Access Compliance Report

Public Rights-of-Way

(Curb Ramps)

Intersection ID: N/A	Main Street: FREEDOM_DR	Cross Street: N_I-85_RA	Location: S
ADA ID: 75583E07C810	Ramp Type: Directional1	Initial Pass/Fail: Pass	Overall Compliance: No
Severity Score: 0.25			
Codes/Mitigation Info/Possible Solution		Field Measurements/Component Compliance

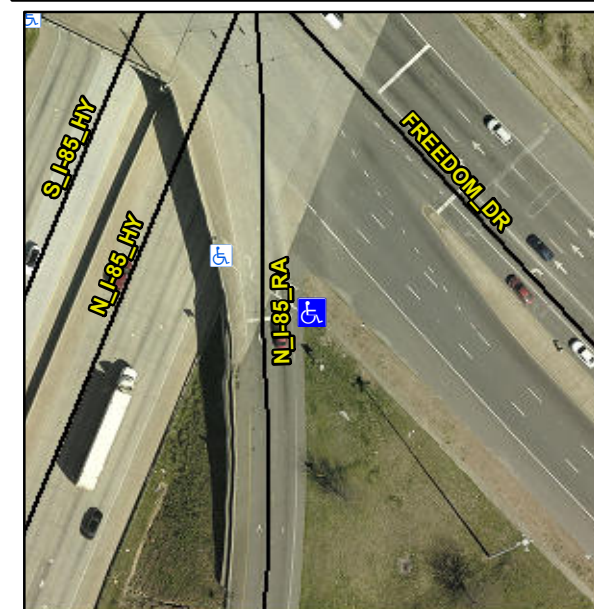
LOCATED ON ISLAND

R304.5.3, R305.2

Compliance	Description	Data	Compliance	Description	Data
N/A	Ramp Length (in)	58.0	Yes	Grade Break?	Yes
Yes	Ramp Width (in)	60.0	Yes	Grade Break Slope (%)	0.3
Yes	Ramp Slope (%)	0.1	No	Grade Break XSlope (%)	3.6
No	Ramp XSlope (%)	2.6			
N/A	Flare Type LT	N/A	N/A	Flare Type RT	N/A
N/A	Flare Slope LT (%)	N/A	N/A	Flare Slope RT (%)	N/A
N/A	Flare Traversable LT?	N/A	N/A	Flare Traversable RT?	N/A
Yes	Landing Length (in)	60.0	Yes	DWS Provided?	Yes
Yes	Landing Width (in)	60.0	Yes	DWS Contrast?	Yes
Yes	Landing Slope (%)	0.9	Yes	DWS Length (in)	24.0
Yes	Landing X Slope (%)	2.0	Yes	DWS Full Width?	Yes
N/A	Landing Curb? (Y/N)	N/A	Yes	DWS Offset LT (in)	53.0
N/A	Shared Landing?	No	No	DWS Offset RT (in)	7.0
Yes	Gutter Ponding?	No	Yes	Gutter Slope (%)	0.6
Yes	Gutter Lip Ht (in)	0.0	Yes	Gutter X Slope (%)	1.4
N/A	Painted X Walk1?	Yes		Road Slope (%)	0.6
	X Walk 1 Direction	To NW		Road X Slope (%)	1.3
	X Walk 1 Width (in)	100.0		Clear Space?	Yes

Remove & Replace Entire Ramp.
